Technical change to SKH interfaces

PCN-number: 20211110

Representative SKH interface

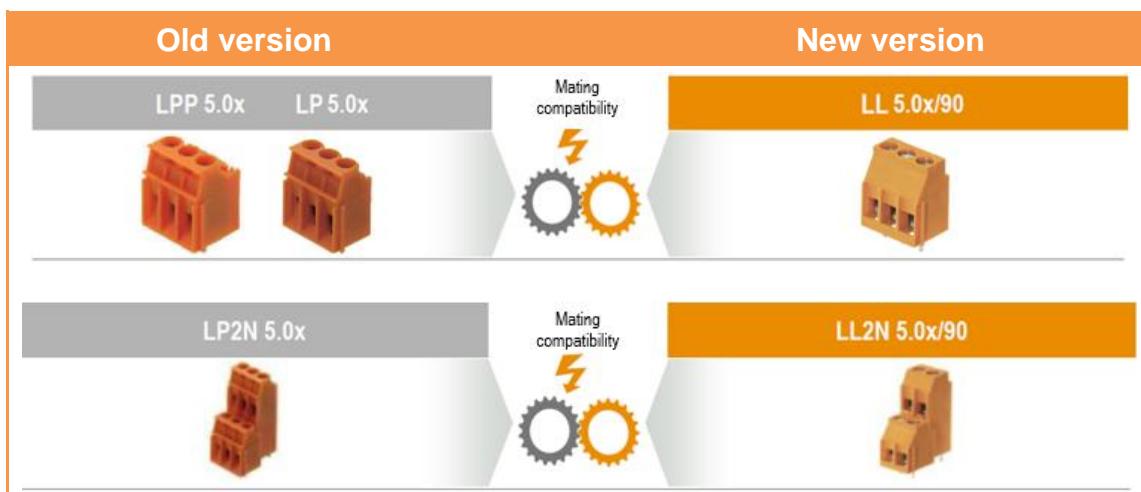
Articles on Section 5 were delivered in the past with LPP, LP and LP2N connectors. Furthermore, they were delivered with Dekafix*

Based on continuous improvement the LPP, LP and LP2N connectors will be replaced by LL and LL2N connectors with KSW strip markers.

Obsolescence of LPP, LP and LP2N connector range.
